Proposed Amendments to the Operative Western Bay of Plenty District Plan

Add the Washer Road Business Park Structure Plan to Appendix 7 of the District Plan.

Figure 1: Washer Road Business Park Structure Plan

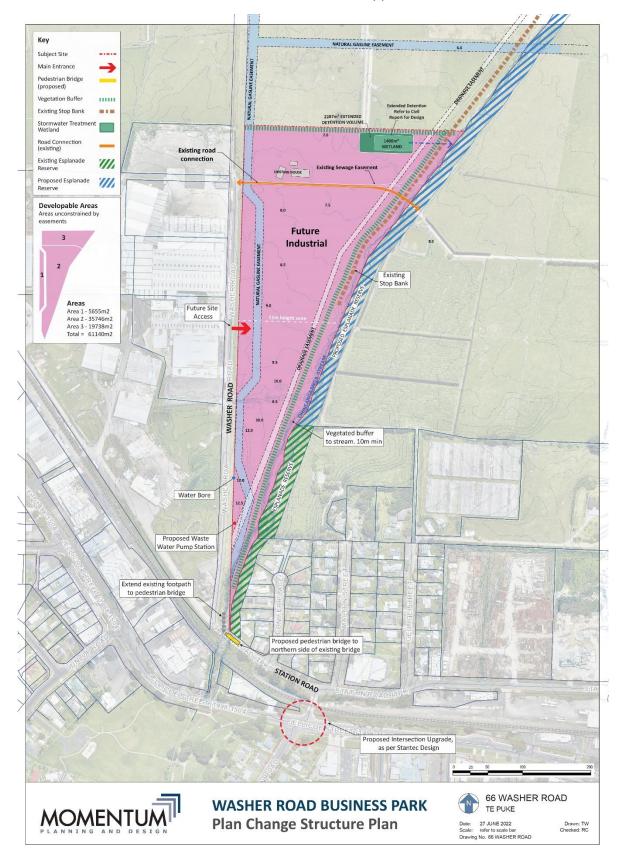
Update Appendix 7 of the District Plan by adding the Washer Road Business Park Structure Plan as per Figure 1 above.

Figure 2: Washer Road Business Park Staging Plan

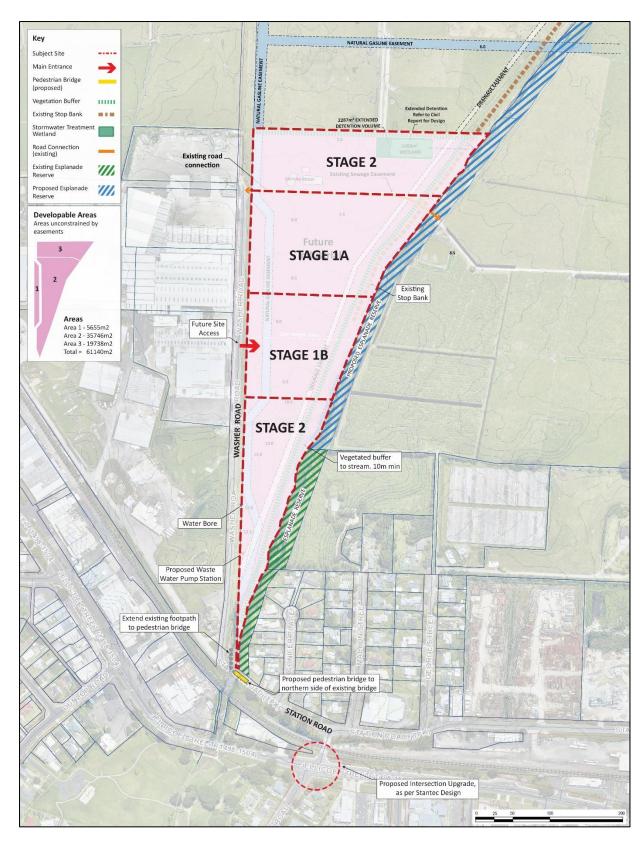
The following Staging is proposed for Washer Road Industrial to enable the site to be developed progressively. Earthworks and preloading of the site are required to prepare the land for future industrial use.

Stage 1 Infrastructure Works

- Sewer pump station and rising main
- Stormwater pond (extended detention)
- Water supply
- Landscape buffer adjacent to Stage 1, excluding gas easement area
- Form primary road entrance to industrial land
- Cycle/Pedestrian bridge over Ohineangaanga Stream
- Extension of the footpath south along Washer Road to connect to cycle pedestrian bridge.
- Amend the priority control on Station Road single lane bridge to provide priority for westbound traffic movements.

Stage 2 Infrastructure Works

Intersection upgrade at Cameron Road and Jellicoe Street, with a signalised intersection design in general accordance with the Stantec Concept or alternate layout approved by Council.

Non-compliance with the proposed staging works above will render development or subdivision within the Washer Road Industrial Structure Plan area a discretionary activity.
